DA NO: DA-2023/269
ADDRESS: 13 CAMMARAY ROAD, CASTLE COVE NSW 2069.
PROPOSAL: ALTERATIONS AND ADDITIONS TO EXISTING DWELLING AND GARAGE AND LANDSCAPING, WITH ASSOCIATED WORKS.
RECOMMENDATION: APPROVAL
ATTACHMENTS:
1. SITE DESCRIPTION AND AERIAL PHOTO
2. DEVELOPMENT CONTROLS, STATISTICS, DEVELOPER CONTRIBUTION & REFERRALS
3. ASSESSMENT UNDER *WDCP*
4. SUBMISSIONS TABLE
5. APPLICANT'S CLAUSE 4.6 SUBMISSION – HEIGHT
6. OFFICER'S CLAUSE 4.6 ASSESSMENT – HEIGHT
7. SECTION 4.15 (79C) ASSESSMENT
8. SCHEDULE OF CONDITIONS
9. NOTIFICATION MAP
RESPONSIBLE OFFICER: RITU SHANKAR - TEAM LEADER
AUTHOR: OLIVIA NAVRATIL – DEVLEOPMENT ASSESSMENT OFFICER
REPORT DATE: 29 MAY 2024
MEETING DATE FOR ED ELECTRONIC DETERMINATION

1. PURPOSE OF REPORT

The purpose of this report is to seek determination by Willoughby Local Planning Panel (WLPP) of Development Application DA-2023/269 for the *alterations and additions to existing dwelling and garage and landscaping, with associated works* at 13 Cammaray Road, Castle Cove.

Figure 6: Second Floor Plan – encroachment to the 2.5m side setback is detailed (extract is prior to the reduction of the balcony size).

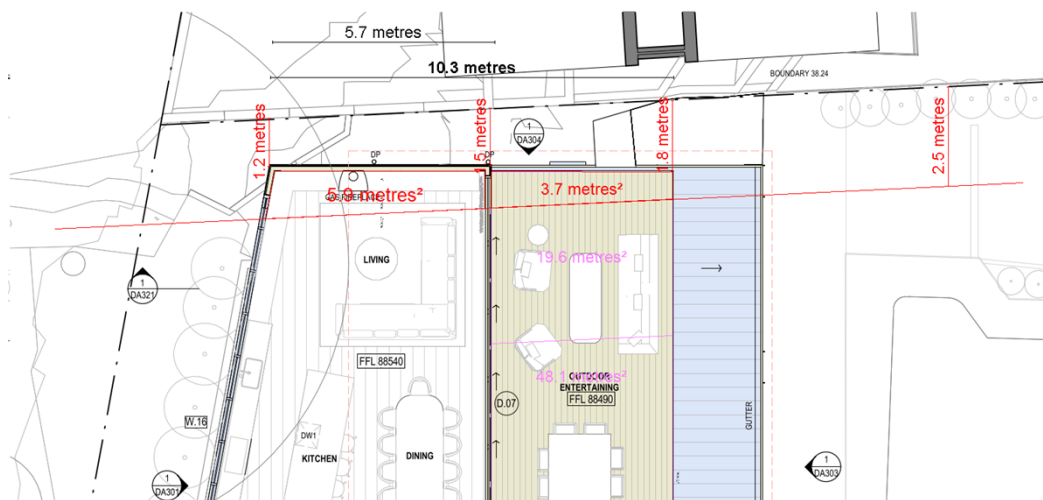
The second floor addition is required to have a 2.5m side setback in accordance with Control B.4 under Part C, Attachment 2 of the *WDCP*. The second floor side setback does not comply, proposing a 1.2m-1.8m side setback, with the following encroachments considered:

- 5.9m² dwelling GFA encroachment
- 3.7m² balcony encroachment
- The boundary is 38.24m deep and the extent of the proposal protruding into the side setback is 10.3m deep (26%). The reduction in the balcony size would result in a 5.7m (14%) depth that protrudes into the side setback.

Figure 8: Existing (top) and proposed (bottom) Height Blanket Diagrams – encroachment to the 8.5m height requirement is shown.

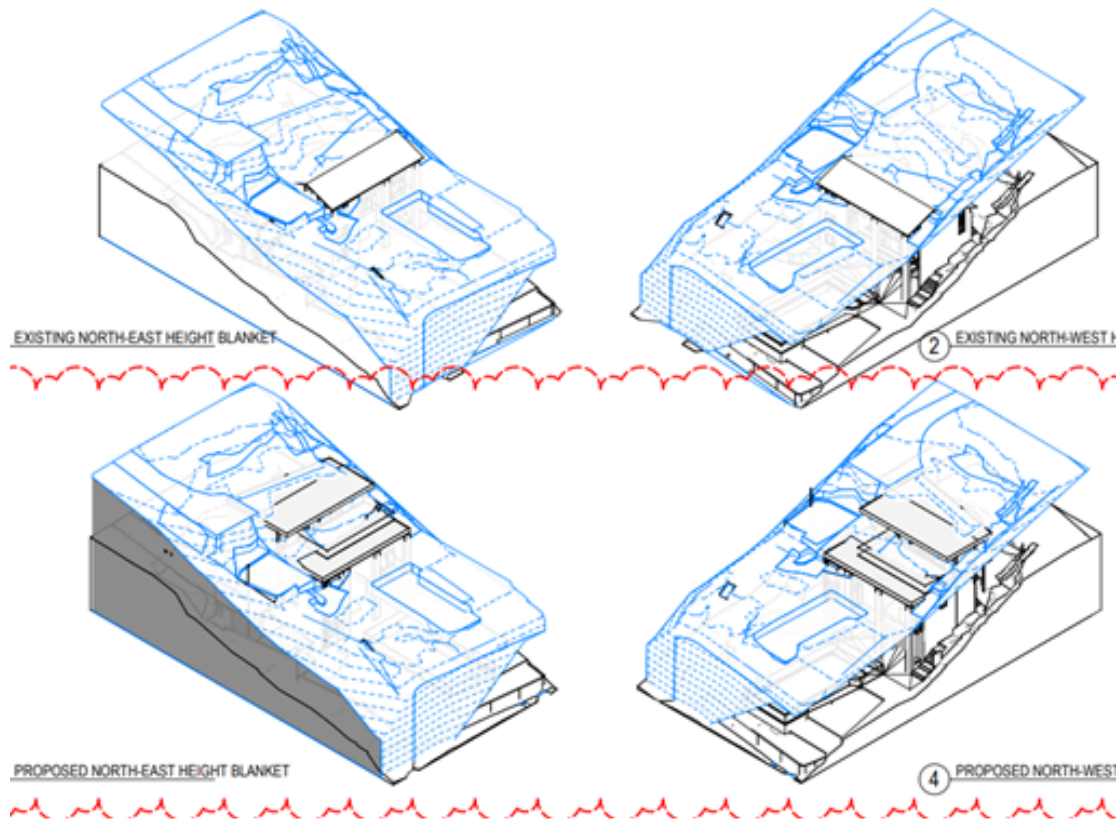
- a) The proposal will reduce the existing maximum building height and include a second floor addition with a balcony that contravenes the building height development standard. The perceived bulk is predominantly compliant and existing, with the breach relating to the existing dwelling roof, the rear corner, eave and balcony of the proposed addition. Refer to figures 8-9 below:

Figure 9: Section Plan – encroachment to the 8.5m height is detailed.

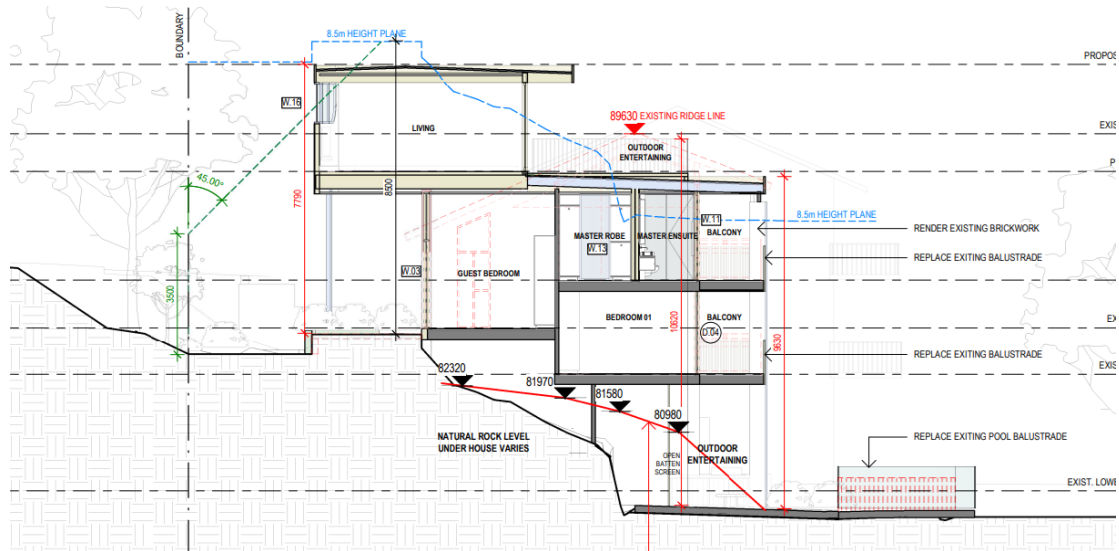
- b) The Development Application contains the following breaches to the height of buildings development standard:
 - i) Existing dwelling breach – The existing roof is reduced from a height of 11m to 9.9m, resulting in a 1.4m variation. Extent of the variation is 16%.
